TECHNICAL INFORMATION

- Subject** ▶ Change of Switch
- For Models** ▶ See below.
- Country** ▶ All countries
- Description** ▶ Some constituent parts of switch have been modified in order to improve the switch in durability.

Trigger Shaft (Color: Black → White)

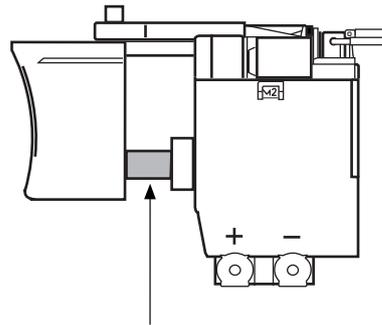
The color of Trigger Shaft has been changed from black to white to distinguish the new switch from the current switch as illustrated below. However the part number and the wiring remain unchanged.
